Bayside Planning Panel

Item No	6.2
Application Type	Development Application
Application Number	DA-2017/107
Lodgement Date	29 September 2016
Property	1-3 Oriental Street, Bexley
Owner	Y Z Z Investment Pty Ltd
Applicant	Mr Peter Yuan
Proposal	Construction of a four (4) storey residential flat building comprising 15 residential units, roof terrace, basement car parking and demolition of existing buildings.
No. of Submissions	One (1) in opposition
Cost of Development	\$ 4,711,892.00
Report by	Brendon Clendenning, Creative Planning Solutions Pty Limited Pascal van de Walle, Coordinator Development Assessment

Bayside Planning Panel Assessment Report

Application Number:	DA-2017/107
Date of Receipt:	29/09/2016
Property:	1-3 Oriental Street, BEXLEY NSW 2207
Lot & DP/SP No:	Lots 36 and 37 in DP 5216
Owner:	Y Z Z Investment Pty Ltd
Applicant:	Mr Peter Yuan
Proposal:	Construction of a four (4) storey residential flat building comprising 15 residential units, roof terrace, basement car parking and demolition of existing buildings.
Value:	\$ 4,711,892
Recommendation:	Refusal
No. of submissions:	One (1) in opposition
Author:	Brendon Clendenning, Creative Planning Solutions Pty Limited
Date of

Figure 3 Neighbouring building at 437 Forest Road, viewed from Oriental Street (Steven Layman Consulting, 2016)

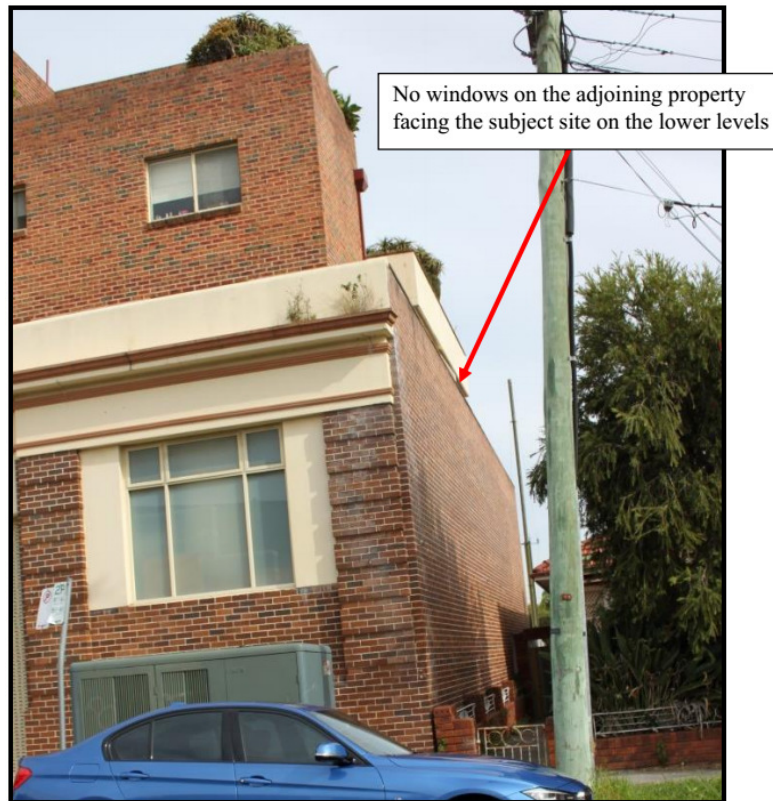
It is agreed that a suitable response to the minimal setback to the blank wall shown above, within 437 Oriental Street, is to provide lesser setbacks than that required by the ADG. However, this wall lies adjacent to the front dwellings of the proposed development, but not adjacent to the rear dwellings. The proposed rear dwellings lay adjacent to the properties from 443-449 Forest Road. Furthermore, the wall is 7m tall, well short of the proposed height of the development, which is in excess of 14m.

Figure 4 12pm midwinter shadow diagrams (Resolut, 2017)

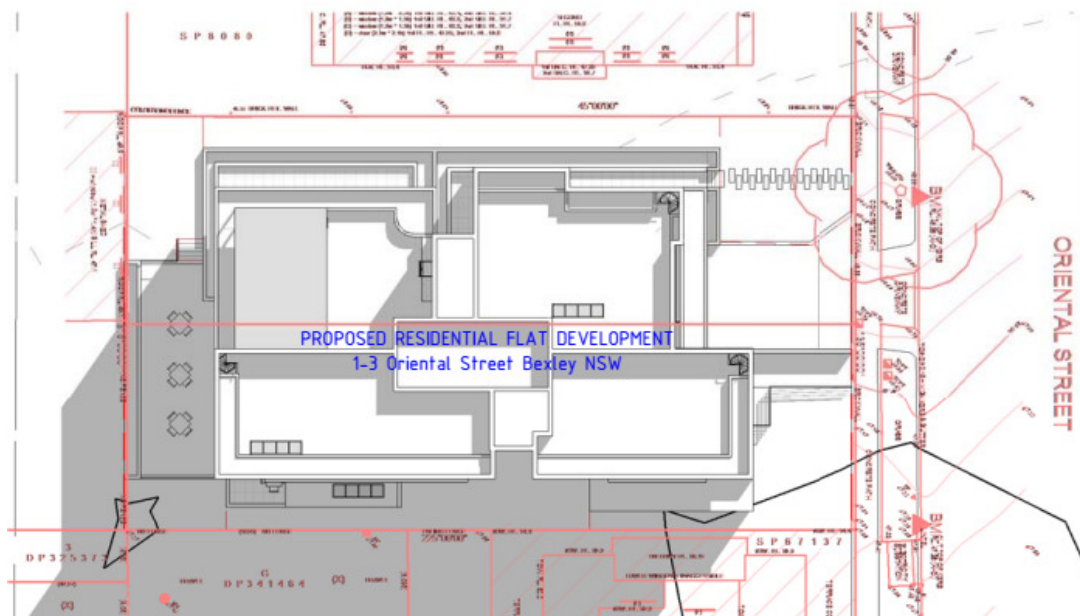
With respect to overshadowing to surrounding properties, Figure 4 provides an example of the information that was provided to demonstrate the impacts to neighbouring properties. The shadow diagram within Figure 4 depicts the overshadowing to neighbouring properties. However, very limited information is provided on the neighbouring properties. No elevation shadow diagrams have been provided to demonstrate the impacts to balconies, etc, and insufficient information is provided to enable any proper understanding of the impacts to ground level overshadowing, as the entirety of the shadows are not shown.

Figure 5 12pm Level 1 midwinter sun path shadow diagrams (Resolut, 2017)

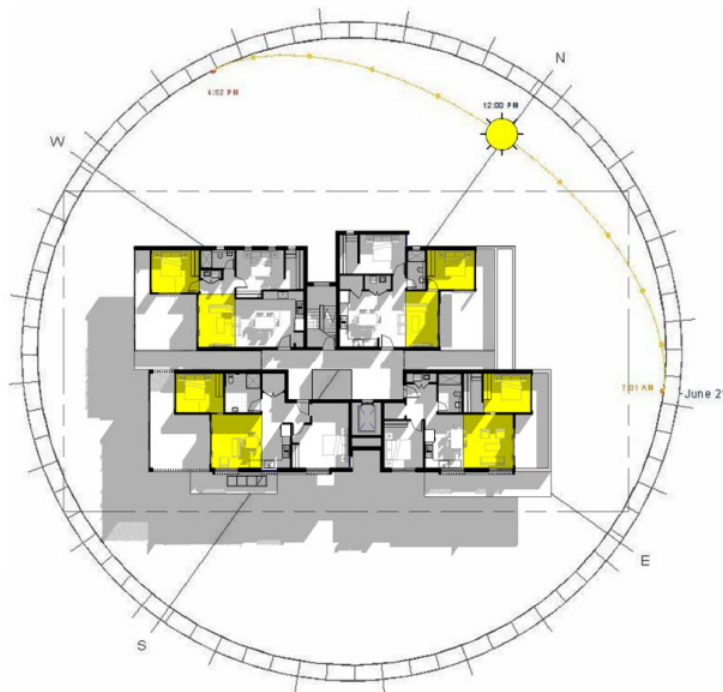
With respect to solar access to the subject property, Figure 5 provides an example of the information that was provided to demonstrate the solar access received by dwellings within the development. The submitted Statement of Environmental Effects indicates that 100% of units receive compliant solar access. However, this is not possible, given:

- The units on the southern corner of the building would be expected to receive very little solar access in midwinter, as all openings face either southwest or southeast.
- Living rooms on the western corner of the building are also oriented towards the south and are unlikely to receive compliant solar access.
- It would be expected that the neighbouring building to the northwest would also cast shadows on the proposed dwellings.

Therefore, it is unlikely that the proposal will be compliant with the controls contained within Part 4A of the ADG. Note that it is unclear what is intended to be depicted by the yellow shading within Figure 3.

Figure 6 12pm Level 3 midwinter sun path shadow diagrams (Resolut, 2017)

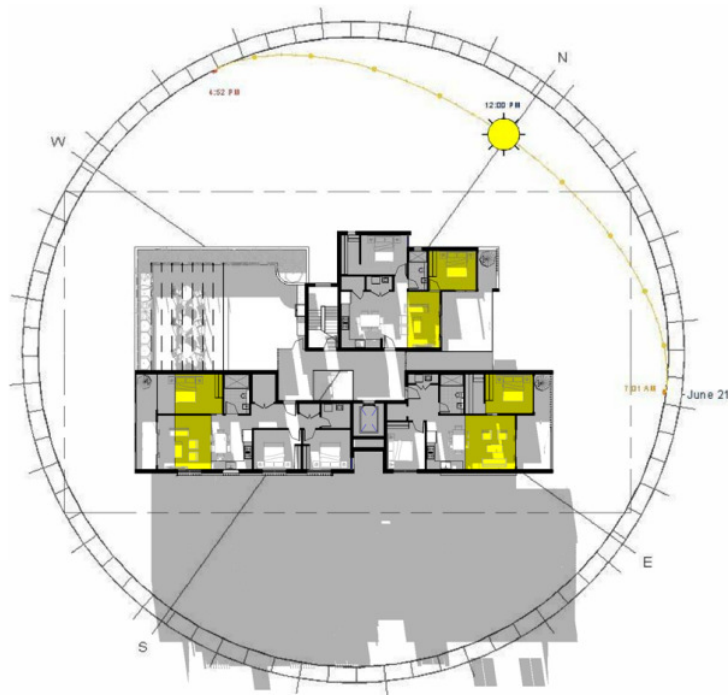
Finally, with respect to overshadowing to the proposed communal open space areas, Figure 6 provides an example of the information that was provided to demonstrate compliance. The direction of the shadow diagrams would be expected to be cast in a southerly direction, identical to those shown within Figure 5, however, the shadow diagrams depict shadows being cast towards the southeast. It is not possible to determine the level of solar access that is received to the communal open space. Excellent solar access should be provided to the Level 3 communal open space, as the ground floor communal open space, provided within a narrow and non-compliant rear setback area, would receive very little midwinter solar access.
